TIMBER SALE PROSPECTUS #6955

REVISION NOTICE #2 - January 11, 2022

Sale Name: Down Range Hardwoods

Sale Number: 61-114-21 Seq#: 1

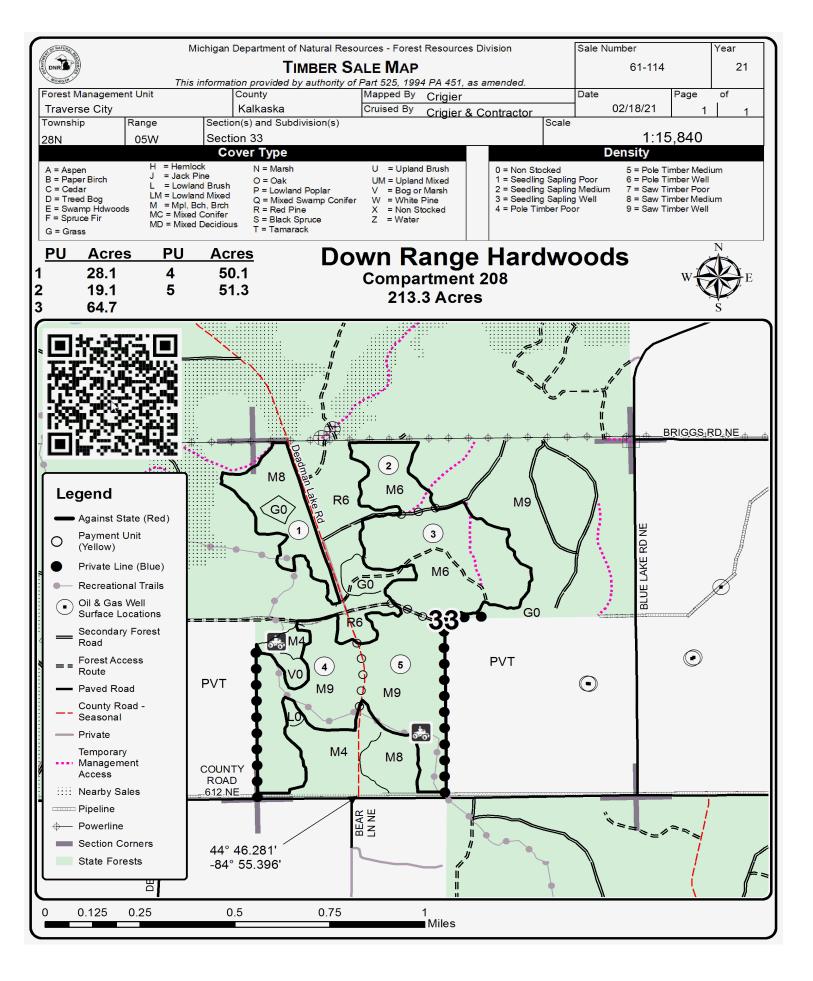
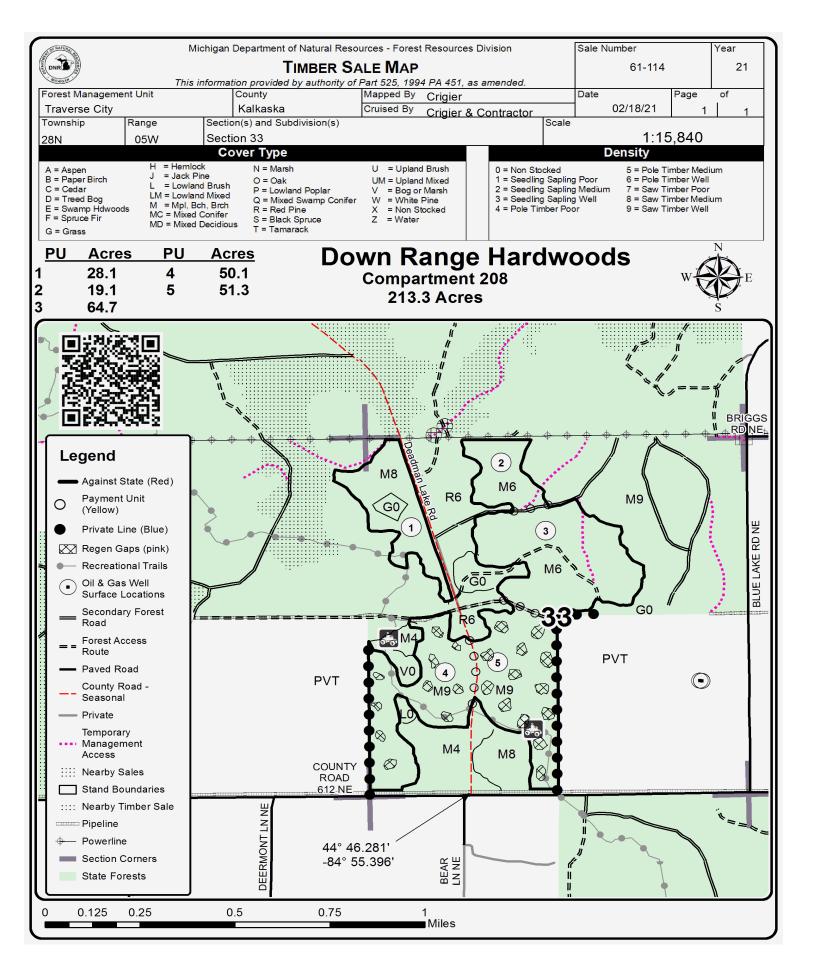
The sale map(s) for the Down Range Hardwoods timber sale (61-114-21) has been updated. Please use the attached sale map(s) when bidding on this sale and disregard the original sale map(s) sent with the prospectus.

There are a number of small, pink lined areas to clearcut within Units 4 and 5, as indicated in specification 2.1.3. These areas have been added to the map. The previous revision for this prospectus updated spec 2.1.3 to include clearcutting the pink lined regeneration gaps and this revision adds an updated map showing the location of these areas.

Within Payment Unit(s) 2-5, all trees are designated for cutting when marked with orange paint above and below stump height, regardless of merchantability. In addition, cut all ironwood, beech, and aspen, except for those marked with an orange 'X'. Cut all trees within the pink boundary line within units 4 & 5.
